Mobile Intel® Pentium® 4 Processor-M

Specification Update

August 2003

Document Number: **250721-017**

Figure 13. System Bus Reset and Configuration Timings

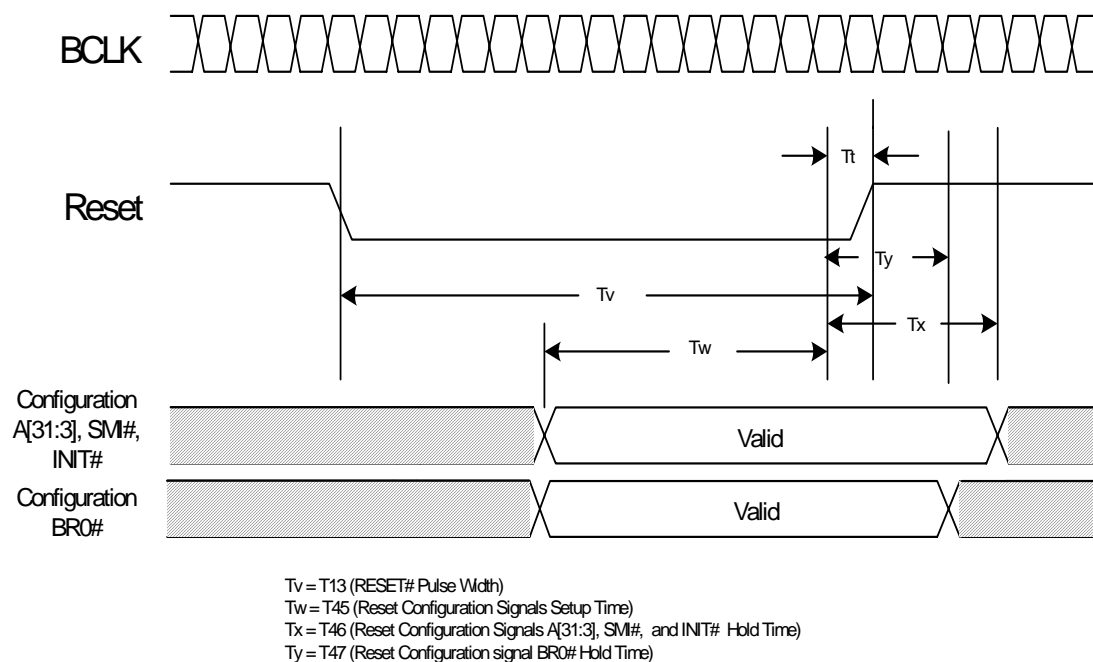
T2. BR0# Maximum Hold Time Specification Change

The BR0# maximum hold time has changed to 2 BCLKs. This change will be shown in the “System Bus AC Specifications (Reset Conditions)” table and “System Bus Reset and Configuration Timings” figure of the *Mobile Intel® Pentium® 4 Processor - M Datasheet*. This change will be incorporated in the next revision of the datasheet.

The following figure will be modified to reflect this change:

T# Parameter	Min	Max	Unit	Figure	Notes
T45: Reset Configuration Signals (A[31:3]#, BR0# INIT#, SMI#) Setup Time	4		BCLKs	13	1
T46: Reset Configuration Signals (A[31:3]#, INIT#, SMI#) Hold Time	2	20	BCLKs	13	2
T47: Reset Configuration Signal BR0# Hold Time	2	2	BCLKs	13	2
